Access Compliance Report

(Curb Ramps)

Intersection ID: 49946	Main Street: OPEN_BOOK_LN	Cross Street: KUYKENDALL_RD	Location: W
ADA ID: B6951921F2BC	Ramp Type: BlendTrans1	Initial Pass/Fail: Pass	Overall Compliance: No
Severity Score: 5			
Codes/Mitigation Info/Possible Solution		Field Measurements/Component Compliance

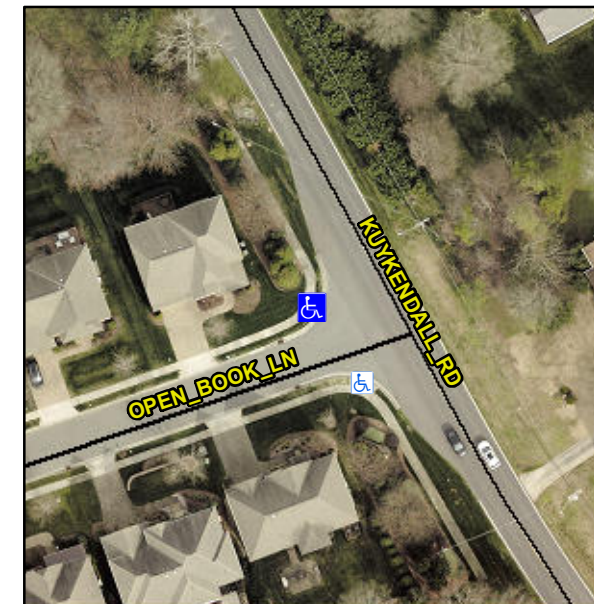
Not Found, R304.2.2-Perp, R304.3.2-Para, R304.5.4

N/A	Ramp inside XWalk1?	N/A	N/A	Ramp inside XWalk2?	N/A
	Road Slope (%)	1.4		Clear Space?	Yes
	Road X Slope (%)	3.4	N/A	Clear Space to XWalk (in)	N/A
Yes	Any Obstructions?	No	Yes	Storm Grate/Utility Hazard?	No
	Obstruction Type			Storm Grate/Utility Type	
		N/A			N/A
			Yes	Surface Condition? (G/P)	Good
			No	Curb Slope (%)	23.5

Remove & Replace Curb Ramp With Two New Directional Ramps or Equivalent. Remove & Replace Gutter.
